## **JACKSON STREET SUBDIVISION, RENEA'S** **ADDITION TO**

APPLICATION NUMBER 10 DATE April 4, 2013  
APPLICANT Jackson Street Subdivision, Renea's Addition to  
REQUEST Subdivision

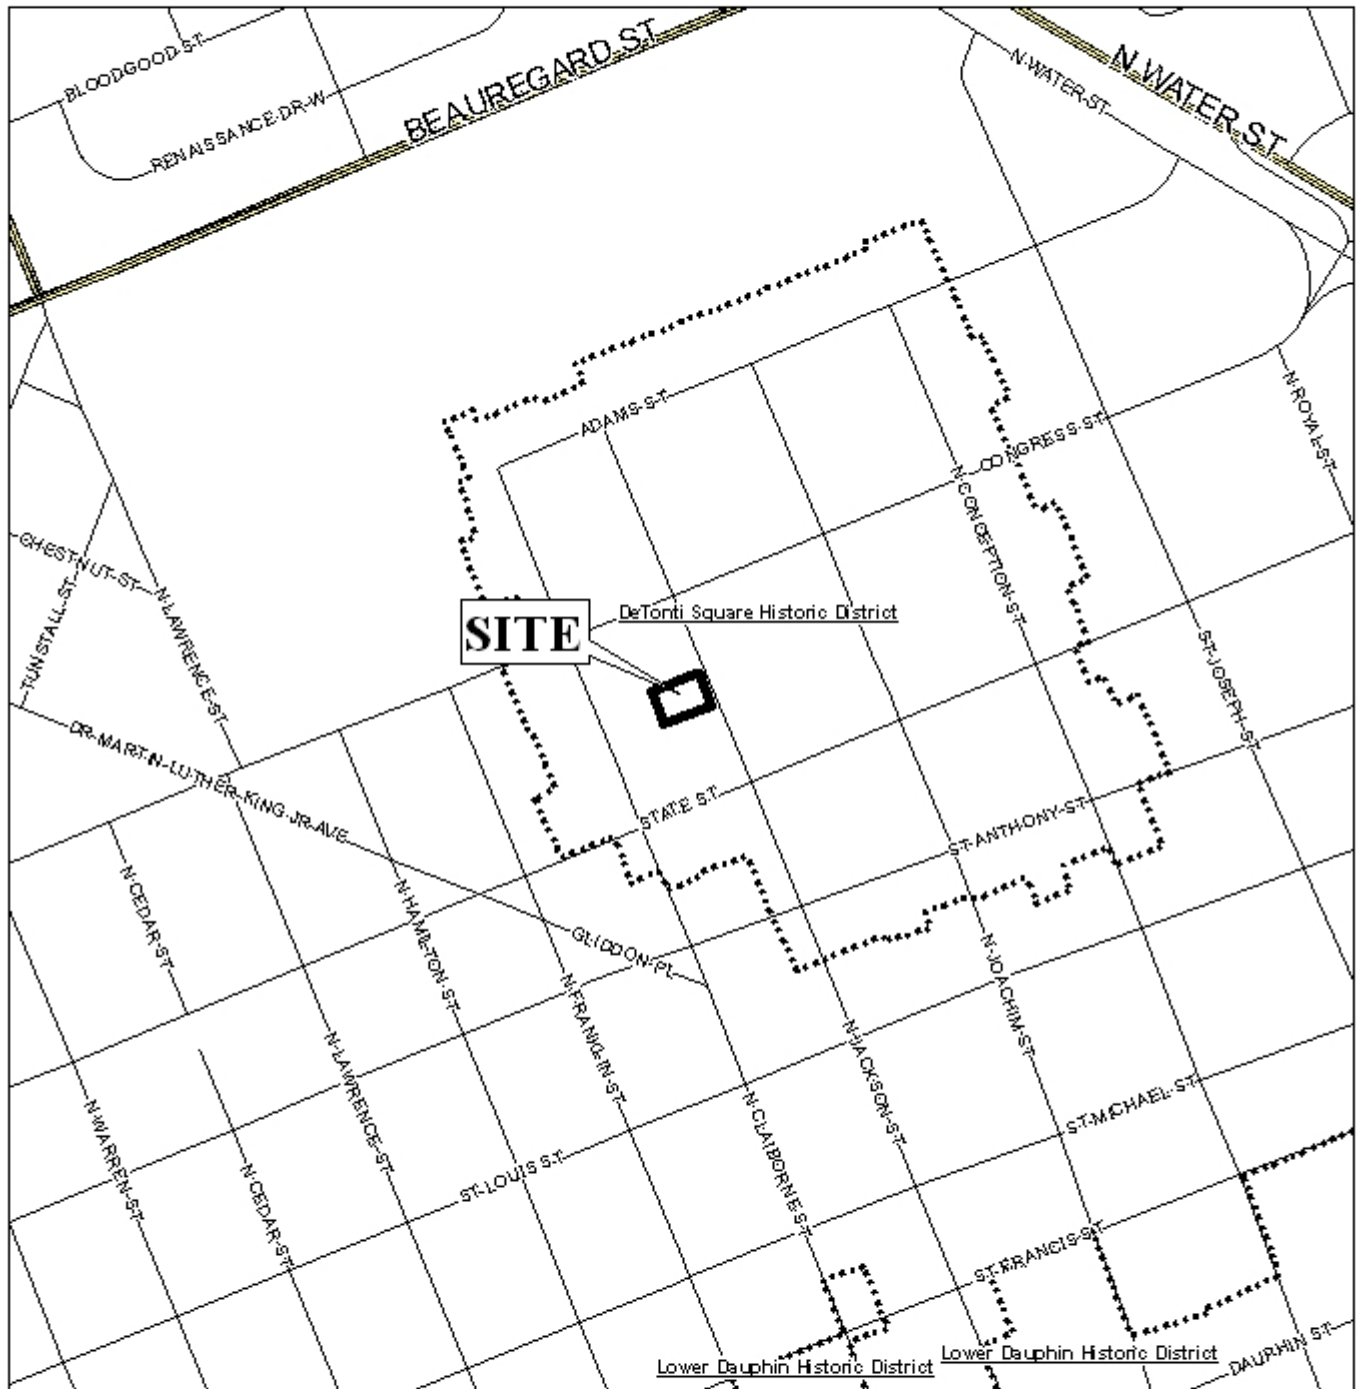
The site fronts onto North Jackson Street, a minor street with a current 50' right-of-way; therefore, no dedication would be required. As a means of access management, a note should be required on the Final Plat stating that the lot is limited to one curb cut to North Jackson Street, with the size, location, and design to be approved by Traffic Engineering and conform to AASHTO standards.

As the site is located within an R-B, Residential-Business District, the Zoning Ordinance allows a 5' front minimum building setback line along North Jackson Street. A waiver of Section V.D.9. of the Subdivision Regulations would be required and would be in order to allow such. And as the site is located within the De Tonti Square Historic District, and front yard setbacks may receive further relief from the 5' normally required in R-B districts, a note should be placed on the Final Plat stating that the front minimum building setback may be governed by that allowed under Section 64-3.G.3.a.(1) of the Zoning Ordinance in lieu of the 5' setback.

The plat should be revised to label the lot with its size in both square feet and acres, or a table should be furnished on the Final Plat providing the same information.

The site appears to be located within an AE and X-Shaded flood zone. The presence of a flood zone would indicate that the area may be environmentally sensitive; therefore, if approved, the approval of all applicable federal, state and local environmental agencies would be required prior to the issuance of any permits or land disturbance activities.

As R-B districts allow for either residential or commercial use, a note should be placed on the Final Plat stating that any lots which are developed commercially and adjoin residentially developed property must provide a buffer, in compliance with Section V.A.8. of the Subdivision Regulations.

With a waiver of Section V.D.9. of the Subdivision Regulations, the plat meets the minimum requirements and is recommended for tentative approval, subject to the following conditions:

- 1) placement of a note on the Final Plat stating that the lot is limited to one curb cut to North Jackson Street, with the size, location, and design to be approved by Traffic Engineering and conform to AASHTO standards;

- 2) retention of the 5' minimum building setback line along North Jackson Street;
- 3) placement of a note on the Final Plat stating that the front minimum building setback may be governed by that allowed under Section 64-3.G.3.a.(1) of the Zoning Ordinance in lieu of the 5' setback;

- 4) revision of the plat to label the lot with its size in square feet and acres, or the furnishing of a table on the Final Plat providing the same information;

- 5) placement of a note on the Final Plat stating that the approval of all applicable federal, state and local agencies would be required regarding flood zone issues prior to the issuance of any permits or land disturbance activities;

- 7) placement of a note on the Final Plat stating that any lots which are developed commercially and adjoin residentially developed property must provide a buffer, in compliance with Section V.A.8. of the Subdivision Regulations;
